# PROJECT REVIEW REPORT

<b>Project ID</b>	0875
<b>Project Name</b>	FLORESTAL SANTA MARIA PROJECT
<b>Review Type</b>	Verification Approval
<b>Program(s)</b>	VCS Program
<b>Verification Period</b>	13-April-2019 to 12-April-2022
<b>Project Proponent</b>	Caraguá Agronegócios LTDA;
<b>Methodology</b>	VCS Methodology VM0007, “REDD Methodology Framework (REDD-MF), Version 1.6
<b>VVB</b>	Earthood Services Private Limited
<b>Assessment Criteria</b>	VCS Standard, v4.4,
<b>Date of First Issue</b>	23 December 2023
<b>Date of Second Issue</b>	11 July 2024
<b>Date of Third Issue</b>	31 October 2024
<b>Review Conclusion</b>	Approved
<b>Date of Final Issue</b>	21 March 2025

Fig. 1. Definition of the new leakage belt.

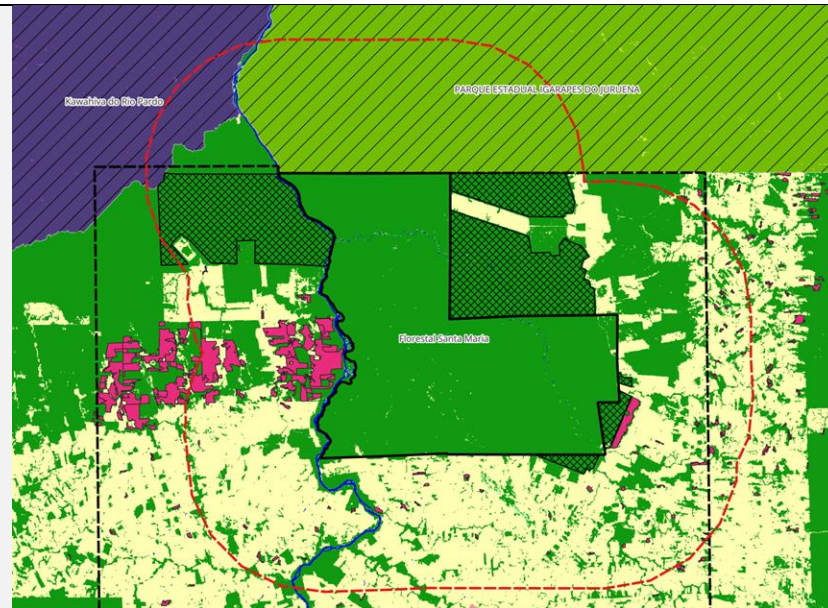
3 Missing and unclear information regarding the Leakage Belt			
	<p><u>Issue</u></p> <ol style="list-style-type: none"> <li>1. It is not clear why a new LB has been delineated.</li> <li>2. The new leakage belt described in Section 3.6.2 and Section 4 of the new PD does not comply with the methodology requirements.             <ol style="list-style-type: none"> <li>a. The LB does not meet the minimum area requirement.</li> <li>b. Insufficient evidence is provided to request relaxation of up to 50% on the</li> </ol> </li> </ol>	<p><b>Round 1</b></p> <p><u>PP Response</u></p> <p>1) A new leakage belt was defined for two reasons: i) to be consistent with the approach taken for baseline reassessment (more details in Finding 8); ii) because the old LB (employed during the first baseline period) did not conform to methodology requirements – the problematic aspects of the old LB were discussed in Sections 3.6.2 and 4.1.1 of the submitted PD. In the update versions, amendments</p>	<p>Closed</p>

<p>similarity criteria between PA and LB, considering the availability of large forest areas surrounding the project that were not included in the LB (i.e., forest areas located north and west of the PA).</p> <p><u>Action Required</u></p> <ol style="list-style-type: none"> <li>1. The VVB must assess that the justification provided for modifying the leakage belt are aligned with the VCS standard and the methodology requirements.</li> <li>2. The VVB must ensure that the leakage belt is correctly delineated to meet the minimum size requirement, so that it includes all available forest areas surrounding the PA.</li> <li>3. The VVB must assess the compliance of the newly selected leakage belt with the requirement of the module VMD0007, v3.3</li> </ol> <p><u>Program Rule(s)</u> VMD0007, v3.3, Section 1.1.3</p>	<p>were made in the text to better clarify why we felt this redefinition to be necessary.</p> <p>2a) According to VMD0007, the minimum area requirement can be relaxed when forest areas close to project borders are unavailable to define the LB; we found this to be the case.</p> <p>2b) The forest areas to the north and west of the PA are not adequate for defining a new LB. Referring to the figure inserted below: the forests to the north are located in either indigenous land (the “Kawahiva do Rio Pardo” reserve, in the northwest) or conservation unit (the “Parque Estadual Igarapés do Juruena”, to the northeast) and therefore are not eligible by the land tenure similarity criterium. Meanwhile, most of the forests to the west of the PA (and within a 15 km buffer) that existed in 2019 had already been deforested by the time the first version of the PD was completed, and were thus excluded from the new LB (hashed areas) – the polygons coloured correspond to a selection of features from the PRODES dataset [Ref. 1] in the Mato Grosso state, which were mapped from satellite images taken in July/2022 (the first version of the PD was issued in August/2022). The background image is the MapBiomass Col 7 coverage data for 2019.</p>

Under these circumstances, we believe the new LB is adequately defined and the relaxation of similarity criteria is justified.

However, when reviewing the “Similarity Analysis” subsection (within Section 4.1.1) we noticed it was not fully conforming to VMD0007 guidelines. The analysis has been updated and the subsection was rewritten. Because the settlement density calculation in the new analysis employs buffers zones of 2 km around target areas (instead of 1 km) a new methodology deviation had to be reported. The conclusion of the analysis remains the same (all regions satisfy all similarity criteria within the allowed margins).

Figure 1 UPA's and Verra cordinates

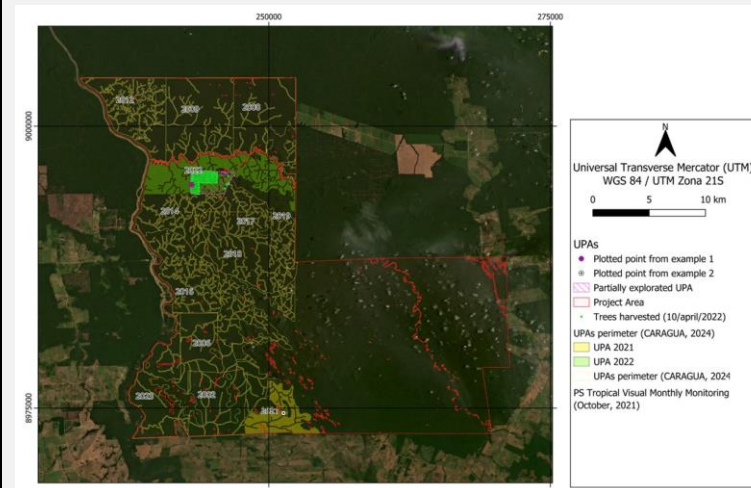
Planet high resolution imageries show some tree cover loss during the monitoring period (see Background Section). It is not clear if it qualifies as a loss event.

1. The VVB must details how the emissions related to the tree cover loss was quantified. If it qualifies as a loss, the details must be integrated in a loss event report and the related emissions must be discounted from this monitoring report ERRs.
2. The VVB must assess if the tree cover loss qualifies as a loss event. If it qualifies as a loss event, the VVB must verify the *Loss event report*. The monitoring report and the verification report must be updated to discount for the related emissions.

The coordinates of the area indicated in example 1 are located in the UPA (Annual Production Unit) called 2022, which has a total area of 3,005.3227 hectares, as described in AUTEX 3388/2021, with management authorization (AUTEX) for the period from September 24, 2021 to December 31, 2021.

The management of the area started earlier than planned, but with the necessary authorizations from the competent bodies described in AUTEX and was not originally included in the MR. However, this data has been updated excluding a polygon (Figure 2) where the management extraction has taken place, which reinforces that the assumed polygon does not include the UPA area as a method, as it

Fig. 1. Deforestation pattern: 1999 (left) to 2009 (right); hashed area is the old RRD used in the first baseline model.

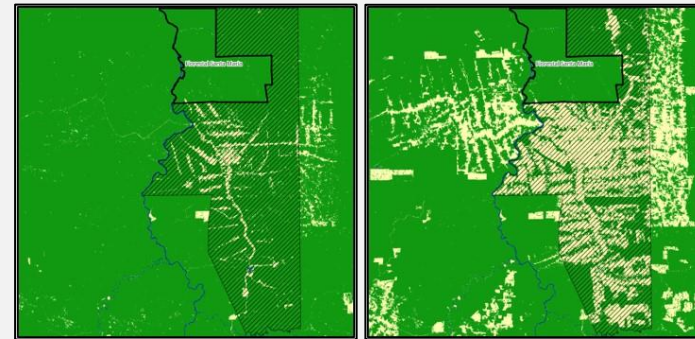
8 Incorrect and unclear deforestation projections			
	<p><u>Issues</u></p> <ol style="list-style-type: none"> <li>1. Areas that were projected to be deforested under the initial baseline (i.e., 18.391,2 ha, or 24% of the PA) have not been discounted from the new baseline projections which put the project at risk of double counting ERRs.</li> </ol> <p><u>Action Required</u></p> <ol style="list-style-type: none"> <li>1. The VVB must ensure that the new baseline projections are adjusted to discount deforestation already credited during the initial baseline (See background section A for guidance).</li> <li>2. The VVB must review the revised documents and update the verification report accordingly, describing the steps taken and the evidence used to assess the updates.</li> </ol> <p><u>Program Rule</u> VM0007, v1.6, Section 6.2 VMD0007, v3.3, Part 3, STEP 3.0 to 3.4</p> <p><u>Background</u></p> <ol style="list-style-type: none"> <li>A. The areas that would have been deforested under the initial baseline (i.e., 18.391,2 ha, or 24% of the PA) must be excluded from the new baseline projections. For instance, <b>the numerical output of the location analysis</b> (i.e., section</li> </ol>	<p><b>Round 1</b></p> <p><u>PP Response</u></p> <p>The exclusion of areas that were projected to be deforested makes sense when the projection for the second baseline period is a direct extrapolation of the prediction made for the first baseline period, in which case the starting point for the second baseline period is the fictitious scenario where the project area is partly deforested. The exclusion is therefore automatic if this recipe is followed, <i>but it is not explicitly required, neither by VM0007 nor VMD0007</i>, when alternative approaches are employed.</p> <p>For reasons explained below, we chose not to follow the recipe for baseline reassessment suggested in VM0007 v1.6 Section 6.2, but rather opted for a full re-evaluation of the baseline scenario, taking as starting point <i>the actual situation of the project area and its surroundings in 2019</i>, which led us to adopt a shorter historical reference period (see reply to Finding #9) and to develop a new risk map for location analysis. And since the project area is fully preserved in 2019, “areas projected to be deforested” are simply inexistent in the model.</p> <p>Our approach was motivated by changes in regional</p>	<p>Closed</p>

deforestation trends over the last years, to wit: a significant drop in deforestation rates was observed in the municipality of Colniza-MT, as depicted in Figure 4.5 of the updated PD, while the deforestation frontier, which during earlier times advanced primarily from south to north, is now embracing the project from both east and west – this is depicted in the figures below which show the evolution of the deforestation pattern during the historical periods considered for the modelling the first (Fig. 1) and second (Fig. 2) baselines.

Fig. 2. Left: main (orange) and secondary roads (grey), background: MapBiomass Col7 2019 forest coverage. Right: main and secondary roads overlaid with “unofficial” roads (green); indigenous lands are indicated by the shaded areas.

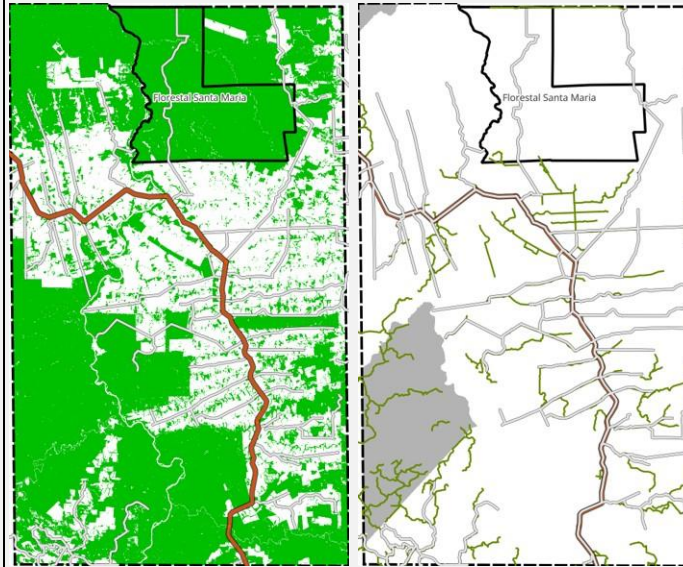
2. The VVB must ensure that section 4.1.3 of the new PD and the deforestation location model are updated to:
  - a. reflect the different road types (i.e., official and unofficial) and the impact they have on deforestation.
  - b. include evidence supporting the decision of defining the variable “distance from deforestation” based on the accumulated deforestation precisely during a 6-years period.
  - c. Provide additional evidence and clarify why the categorical variable “presence/absence of the PA was added to the model.”
3. The VVB must ensure that all the changes requested above are also reflected in the monitoring report.
4. The VVB must assess the revised project documents and updated the verification report accordingly, describing the steps taken to validate and verify the information provided.

Additionally, main and secondary roads are physically similar: both are dirt roads that allow for passage of the same types of vehicles, and which are transitable at the same seasons of the year.

The PD also mentions “unofficial roads” (Section 4.1.1 - Definition of Boundaries - Similarity Analysis) but these were left out of the baseline model since they are not reliably mapped in available datasets. The rightmost panel in Fig. 1 shows some of these minor “unofficial” local roads [Annex D], indicated by ; they also cannot be said to correlate with deforestation the same way as the main and secondary roads, e.g. part of them is located inside indigenous lands (the shaded areas).

**Indigenous lands**

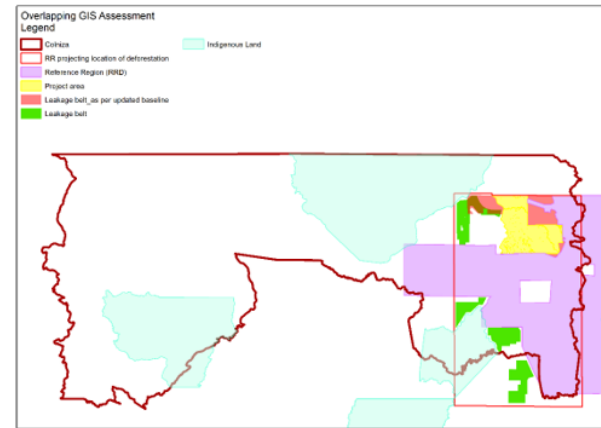
Program Rule(s)

Official database consulted on 8/21/2024, observe the overlaps with indigenous territories of the polygons in blue-green color, source <https://www.gov.br/funai/pt-br/atuacao/terras-indigenas/geoprocessamento-e-mapas>

The section 4.3 of the VR was updated describing how it was confirmed – using what evidence – that the project area does not overlap with the set of public and private lands that could be affected by third parties due to the development of the project. A map (Figure 4) is included in the section to visualize the results of this evaluation.
